Re: Harold D. Thompson Regional Water Reclamation Facility (HDTRWRF)
Lower Fountain Metropolitan Sewage Disposal District (LFMSDD)

Submittal No.:	03200-014
Date of Submittal:	January 31, 2012
Title:	Aeration Basin Level Control Structure
Specification Section:	03200
Manufacturer:	Dalco Industries, Inc.

The referenced submittal, Dalco Industries, Inc. Drawing No. XA-1, has been stamped "***Make Corrections Noted***". Our comments are as follows:

GMS 1/3 1/2 EXCEPT No-2
R/S

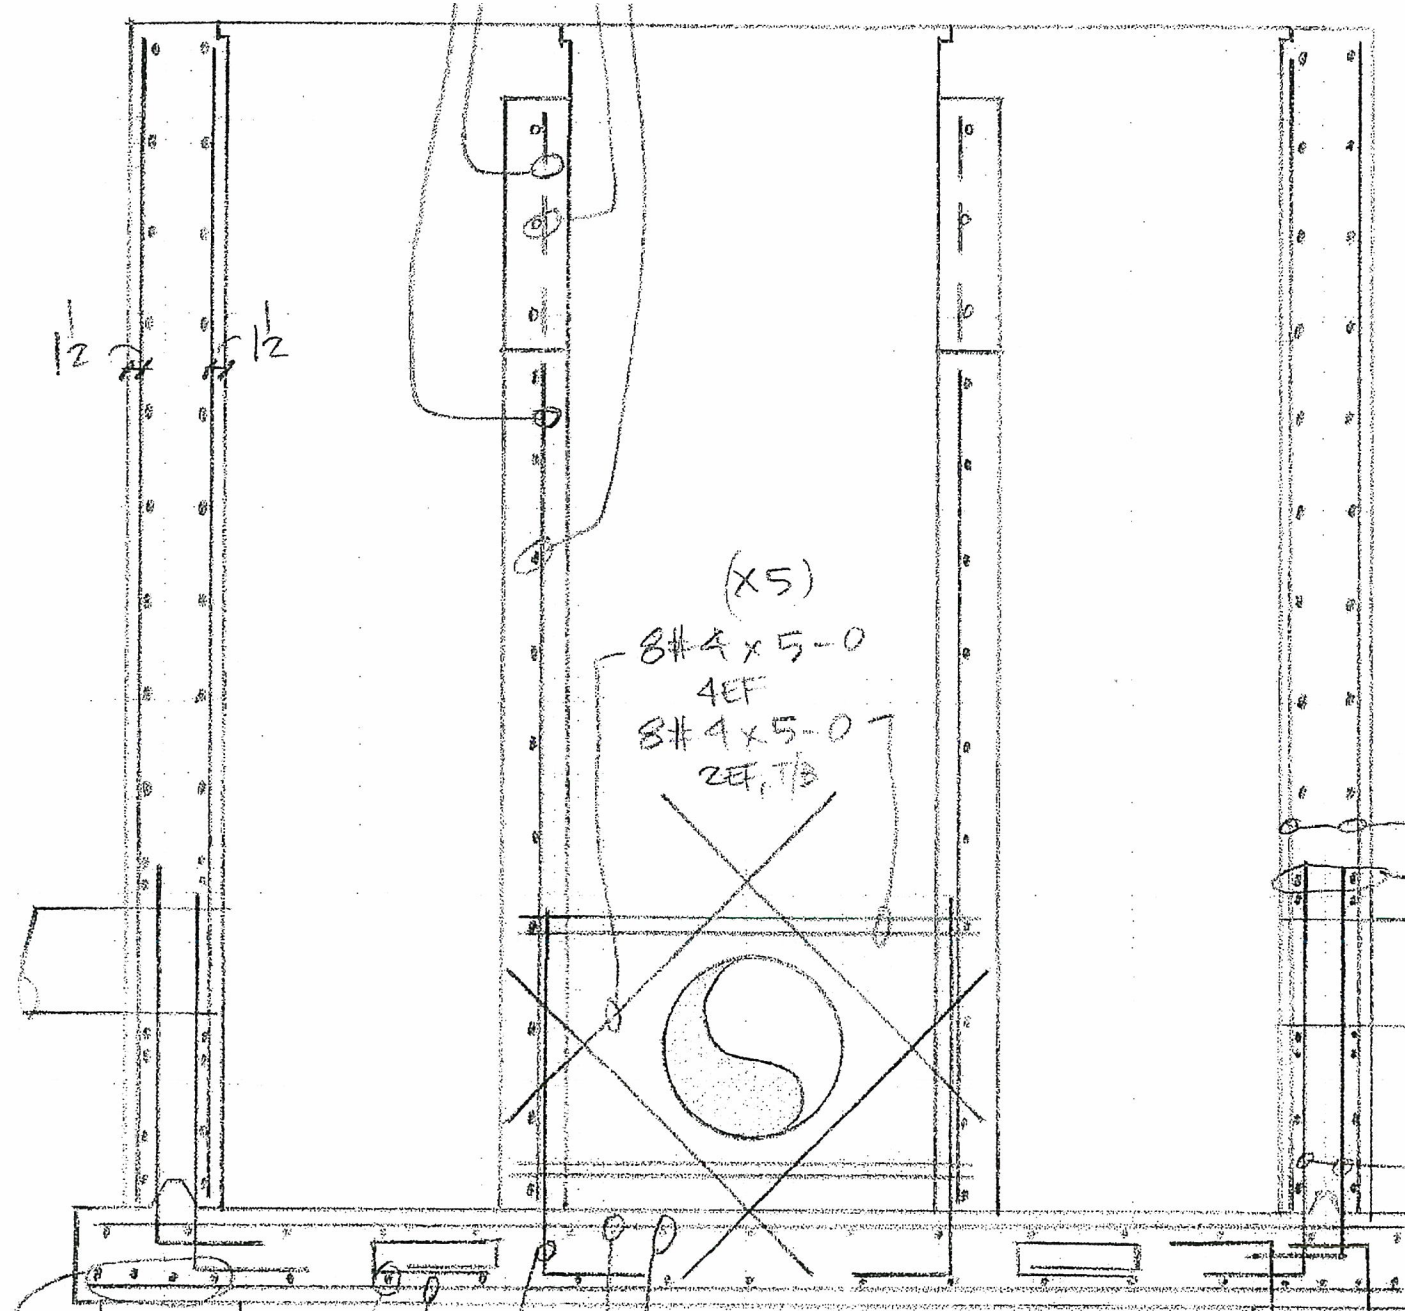
1. Revise the dimensions for Mark 505 as noted on the attached Excerpt No. 2 from Drawing No. XA-1.
2. Review and confirm the dimension "H" for Mark 308 as noted on the Bar Table in Drawing No. XA-1. Refer to Excerpt No. 2 from this drawing.
3. Modify the horizontal bars in the base foundation slab and the designation of caisson steel to reflect as-constructed conditions, Section "A-A", as noted on the attached Excerpt No. 3 from the referenced submittal drawing.
